TO: ALL VOLVO RETAILERS – UNITED STATES and CANADA
RE: RECALL CAMPAIGN 150: BATTERY POSITIVE CABLE (6-CYLINDER ONLY)

VOLVO				TITLE:		GROUP:	NO:	
				RECALL 150		37	150	
Service Manager Bulletin				B+ Cable Check / Adjust		ISSUING DEPARTMENT: Warranty		
				REFERENCE BULLETINS: TNN# 37-150		CARMARKET: United States, Canada		
Service Person- nel: read and initial.	SERVICE MANAGER	SERVICE WRITER	WARRANTY ADMINISTRATOR	DATE:		YEAR	MONTH	DAY
				2006	01	13	Page 1 of 3

SUBJECT: Recall 37-150 B+ Cable Clearance Between the Cable and the Starter Motor Solenoid.
REFERENCE: VIDA

IMG-233844

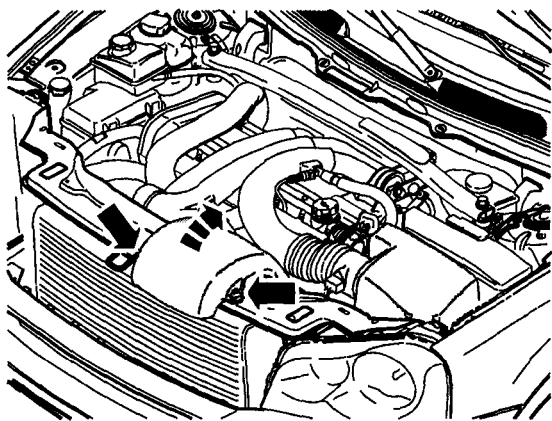
Remove inlet pipe

Note! Only applies to XC90:

Remove the screws, 2 pcs., for the inlet pipe between the front plate and the air filter.
Remove the pipe.

IMG-233845

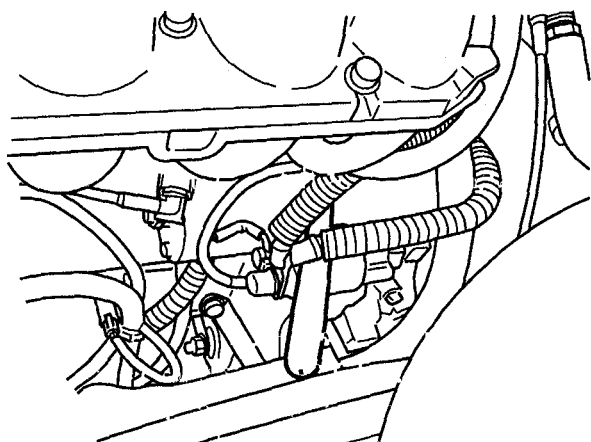
Checking/adjusting B+ cable

Caution! Do not use any tools that conduct electricity.

Check with a Bone Tool 9814071 or similar. The distance between the B+ cable and the solenoid on the starter motor must be at least 4 mm.

If the distance is too small, pull the cable upward until the tool can be inserted easily.
